Access Compliance Report

Public Rights-of-Way

Intersection ID: 18365	Main Street: TRYON_ST	Cross Street: TYVOLA_RD	Location: SW
ADA ID: 032A2CCBAD1C	Ramp Type: PerpDiag	Initial Pass/Fail: Pass	Overall Compliance: No
Codes/Mitigation Info/Possible Solution			Severity Score: 5
			Field Measurements/Component Compliance

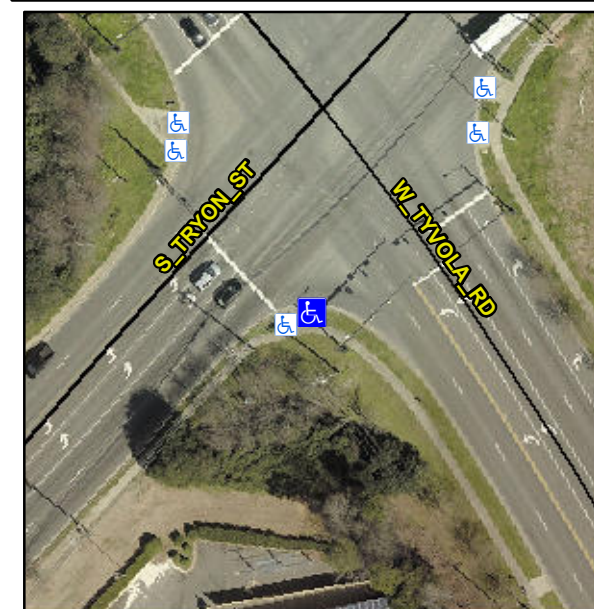
R305.2, R304.5.4, R304.5.3

Compliance	Description	Data	Compliance	Description	Data
N/A	Ramp Length (in)	99.0	Yes	Ramp Slope (%)	5.4
Yes	Ramp Width (in)	48.0	Yes	Ramp XSlope (%)	1.4
N/A	Flare Type LT	Sloped	N/A	Flare Type RT	N/A
N/A	Flare Slope LT (%)	9.8	Yes	Flare Slope RT (%)	6.4
N/A	Flare Traversable LT?	No	N/A	Flare Traversable RT?	Yes
Yes	Landing Length (in)	56.0	Yes	DWS Provided?	Yes
Yes	Landing Width (in)	60.0	Yes	DWS Contrast?	Yes
Yes	Landing Slope (%)	1.2	Yes	DWS Length (in)	24.0
Yes	Landing X Slope (%)	0.4	Yes	DWS Full Width?	Yes
N/A	Landing Curb? (Y/N)	No	No	DWS Offset (in)	4.0
N/A	Shared Landing?	No			
Yes	Gutter Ponding?	No	No	Gutter Slope (%)	6.0
Yes	Gutter Lip Ht (in)	0.0	No	Gutter X Slope (%)	2.2
N/A	Painted X Walk1?	No	N/A	Painted X Walk2?	No
	X Walk 1 Direction	To NE		X Walk 2 Direction	To NW
N/A	X Walk 1 Width (in)	N/A	N/A	X Walk 2 Width (in)	N/A
	X Walk 1 Slope (%)	0.2		X Walk 2 Slope (%)	0.8
	X Walk 1 X Slope (%)	1.9		X Walk 2 X Slope (%)	0.0

Remove & Replace Detectable Warning System. Remove & Replace Gutter.
